© 2016 Mazda Motor of America, Inc.

<b>Subject:</b>  SQUEAKING/GRINDING NOISE FROM REAR BRAKE	<b>Bulletin No:</b> 04-001/16
	<b>Last Issued:</b> 01/14/2016

- This bulletin supersedes the previous bulletins 04-003/15 issued on 11/06/15 and 09/16/15. The REPAIR PROCEDURE has been revised.
- Changes are noted below in Red beside the change bar.

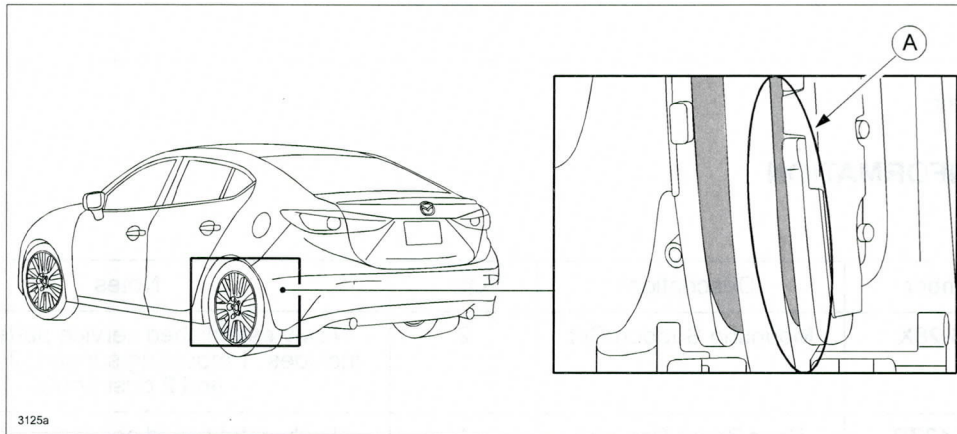
Some vehicles may experience a squeaking/grinding noise from the rear brake even after the brake pedal is released. Upon inspection, the caliper mounting support is corroded and one of the disc pad is abnormally worn out (A). This is caused by vehicle usage in an area using road salt. The surface of the mounting support may swell from corrosion causing premature disc pad wear and brake noise.

To correct the problem, an improved caliper mounting support has been newly established as a service part. The anti-corrosion surface treatment has been changed from Zn to Zn-Ni plating.

## REPAIR PROCEDURE

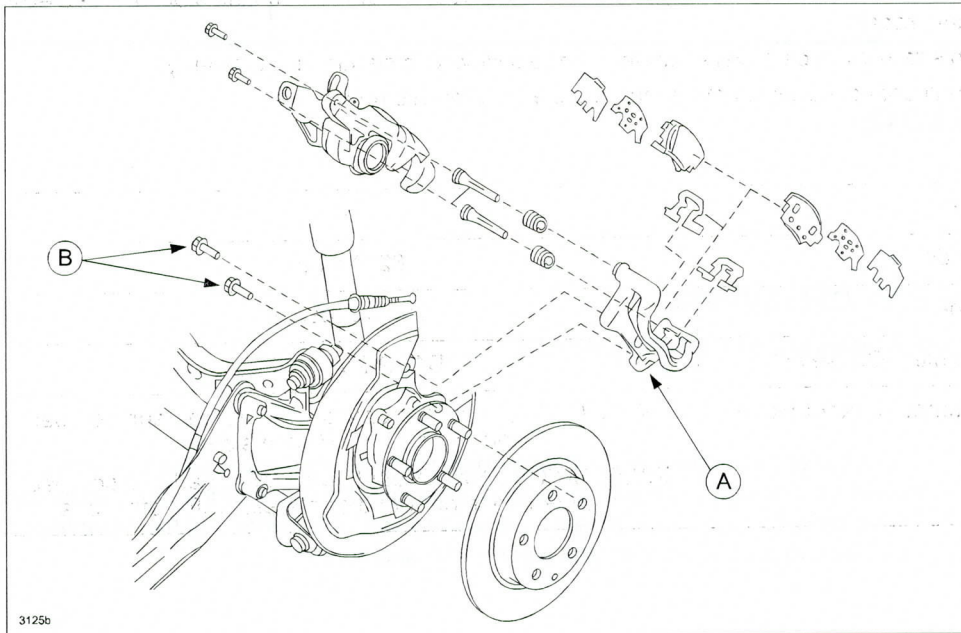
1. Verify that the caliper mounting support(s) is corroded and the disc pad(s) is abnormally worn out.
2. Replace the caliper mounting supports (both sides) with the modified service parts sets and attachments with new parts according to the instructions on MS3 online or the Workshop Manual (section 04-11 REAR BRAKE (DISC) REMOVAL/INSTALLATION).

**CAUTION:** When installing the modified mounting support (A), tighten the installation bolts (B) with the upper limit of the tightening torque specified in the Workshop Manual (6.6 Nm, 48 ft-lbf, 6.7 kgfm).
